## **List of Changes**

## Response to Reviewers' Comments

This manuscript examines the runoff generation processes leading to delayed peaks and proposes a conceptual model for the Xitaizi Experimental Watershed (XEW), North China. Overall, this paper could have the potential to contribute to the literature, but I think improvements in the way of presenting the research questions, the results and discussion would help to highlight the unique aspects of this work.

Figure 3. Three typical SWC-GWL dynamics patterns during rainfall-runoff events. Ra is rainfall amount. Arrows indicate the temporal evolution of the events. Red circles indicate periods of rainfall, while black circles denote post-rainfall periods.

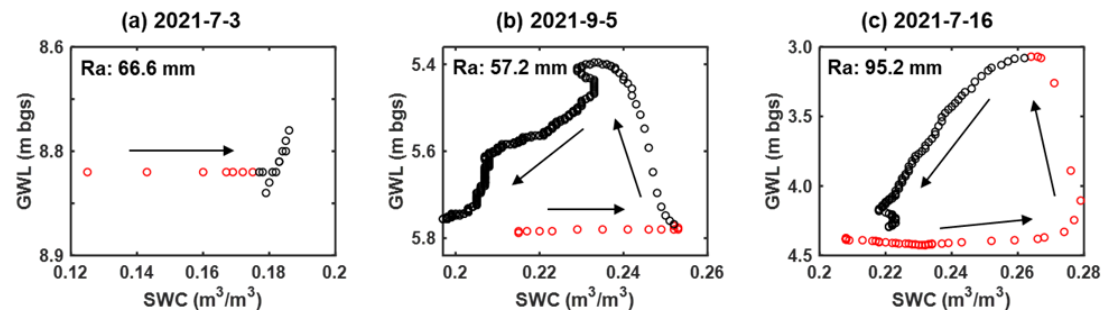
L168-170: Indicate the amount of rainfall in both the text and the figure.

L172: Recommend putting arrows on these figures to show the evolution of the events. Also, please indicate what the red circles indicate.

Thank you for your constructive suggestions. We have added the rainfall amounts for each event in the text and included these values in Figure 3. The revised text and Figure 3 now read:

"In dry conditions, despite 66.6 mm of rainfall, SWC remained relatively low ( $<0.20$ ), with a gradual increase during rainfall followed by stabilization after rainfall ceased." **(Page 14, Lines 300-301)**

**Arrows in Figure 3:** We have added arrows to Figures 3a, 3b, and 3c to indicate the temporal evolution of the events, providing a clearer visualization of SWC and GWL changes during each event.

**Explanation of red circles:** We have clarified in the figure caption that red circles indicate periods of rainfall, while black circles denote post-rainfall periods. **(Fig.3)**

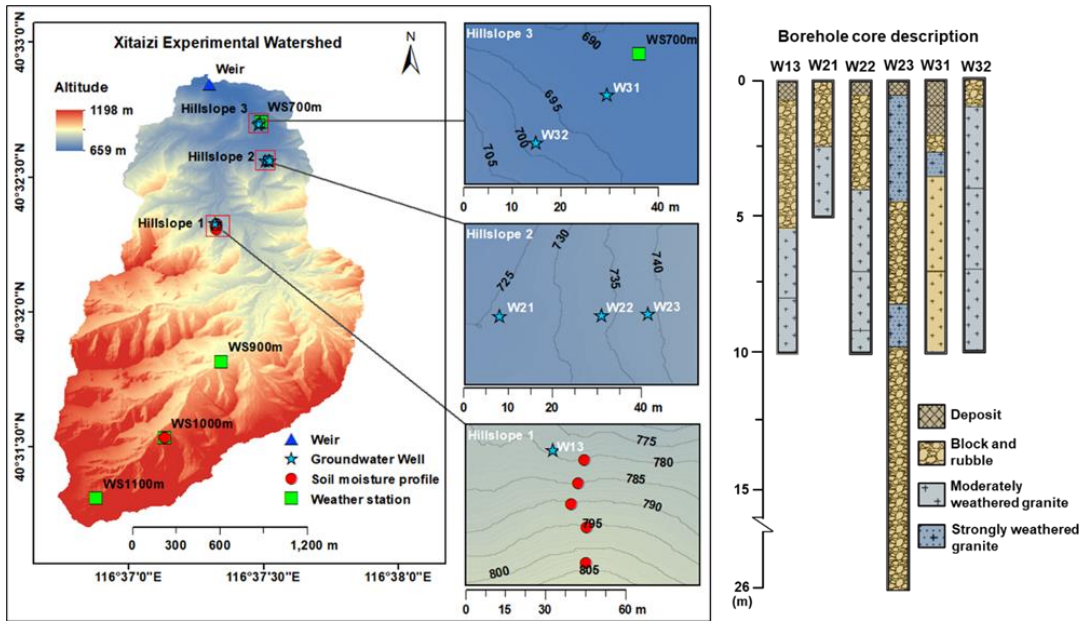
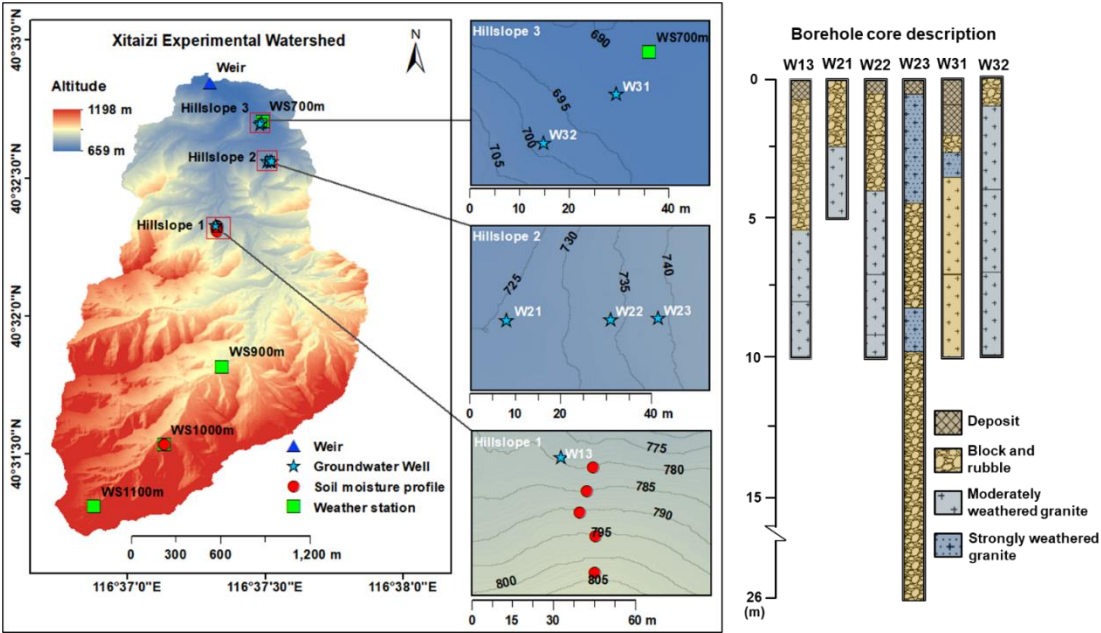
Figure 1. The exact same figure is used in Che et al. (2024, HESS). I wonder if this allowed without referring t the first figure published. It is difficult to see the location of the weather stations. Where are the five soil water profiles located? Are this indicated as “research hillslopes”? or what are research hillslopes? The authors refer to Hillslope 1 in line 116 - but not to the others. An explanation is missing.

Figure 8. It would be nice to have a little map displaying the location of the wells.

We have redrawn Figure 1 to provide a clearer and more readable representation of the elevation and equipment distribution in the experimental watershed. We have enlarged the markers and labels to clearly mark the locations of the weather stations, soil moisture observation profiles, groundwater observation wells, and the three experimental hillslopes. Additionally, we have added a brief description of the borehole cores. The revised Figure 1 and its caption are as follows:

Thank you for your valuable suggestion. We have redrawn Figure 1 and updated the inset maps showing the spatial distribution of the six wells across the watershed, which provides a clearer and more detailed view of the locations of the wells. We hope this addition improves the presentation of the data and makes the figure more informative. Thank you again for your valuable feedback.

Figure 12. Correlation between peak  $I_G$  and the time differences from peak GWL responses on HS1, and HS2 to HS3 ( $\Delta t = t_S - t_{S3}$ ), where  $t_{S1}$ ,  $t_{S2}$  and  $t_{S3}$  are the average lag times of peak GWLs on HS1, HS2 and HS3, respectively. (Page 29, Lines 596–599)

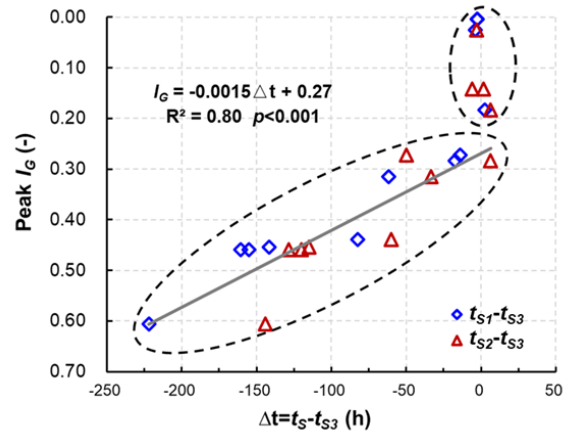
Figure 10: I understand there are two points per event in that graph. Would be nice to know which points refer to  $t_{s1}$ - $t_{s3}$  and which to  $t_{s2}$ - $t_{s3}$ . I wonder if it is correct to use these two points per event to draw a regression line. The x axis indicates that there is 10 days difference between the reaction in one well and another. I do not understand this and I think the paper do not provide enough evidence to the reader to show what is going on. Why the others wells were not included in the analysis?

Thank you for your constructive feedback regarding Figure 10 (now Fig. 12 in the revised manuscript). Your insightful comments have helped us identify areas where additional clarification and evidence are required. Below, we address your concerns point by point:

We have updated Figure 12 to visually distinguish the two points per event by using blue diamonds for  $\Delta t = t_{s1} - t_{s3}$  and red triangles for  $\Delta t = t_{s2} - t_{s3}$ . This visual differentiation improves interpretability and makes it easier to identify the two categories of points.

We clarified in the manuscript that  $t_{s1}$ ,  $t_{s2}$ , and  $t_{s3}$  represent the average lag times of peak GWL calculated from all wells on HS1, HS2, and HS3, respectively. This approach ensures that the analysis incorporates the spatial variability of GWL responses within each hillslope and provides a comprehensive representation of inter-hillslope dynamics.
